UNITED STATES ENVIRONMENTAL PROTECTION AGENCY

Re: Administrative Order V-W-84-007  
Groundwater Sampling Plan

FIGURE 1

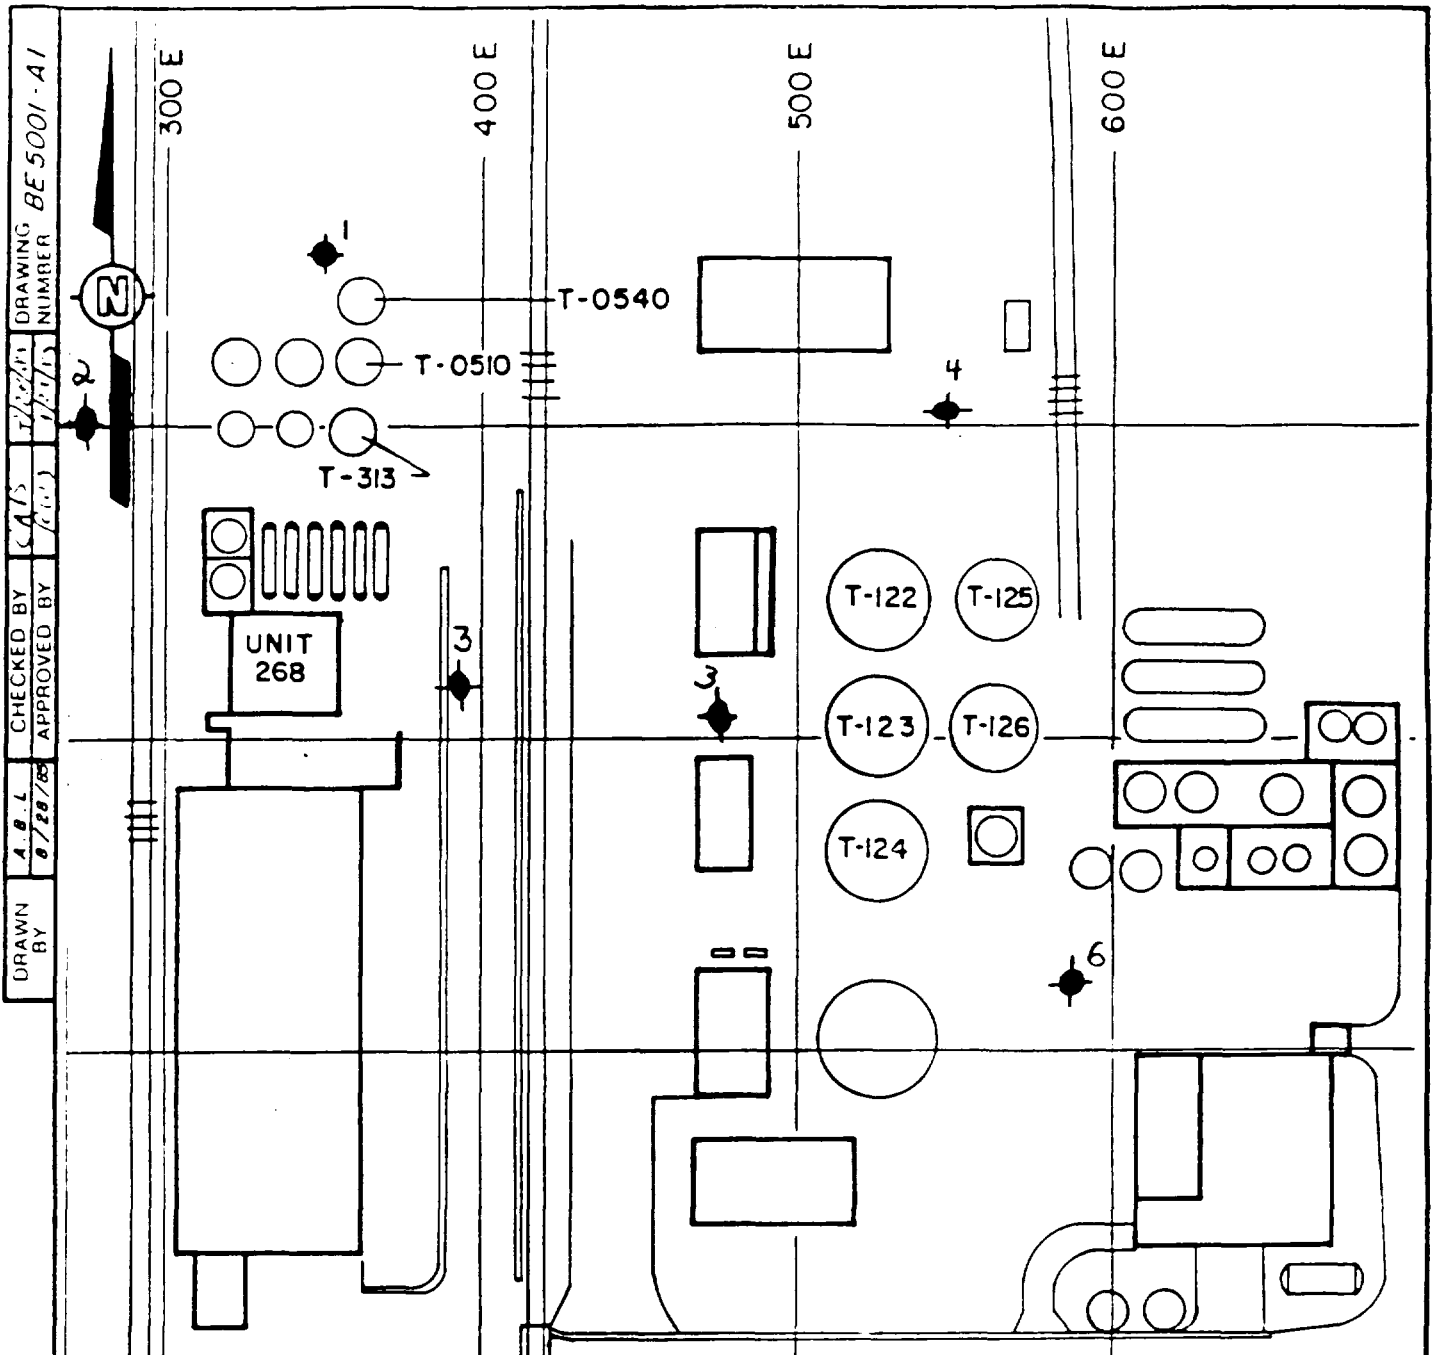
The groundwater monitoring system shown in Attachment 1, Figure 1 will not be adequate to definitively show a negative release should this be the case. With the complicated groundwater system in the area, three monitoring wells located so far from the black tank area and Unit 268 will not confirm the absence or presence of 2,3,7,8-TCDD. The past groundwater pumping practice of Monsanto and the current withdrawals by the State of Illinois further complicates the issue.

With this mind, I believe monitoring wells should be triangulated near the black tank area and near Unit 268. In the black tank area, the wells should be placed as close to the outside of the dike area as possible. I have enclosed a copy of Figure 1 from the IT Corporation proposal with an indication of where the monitoring wells should be placed. I am willing to discuss moving these locations subject to field conditions.
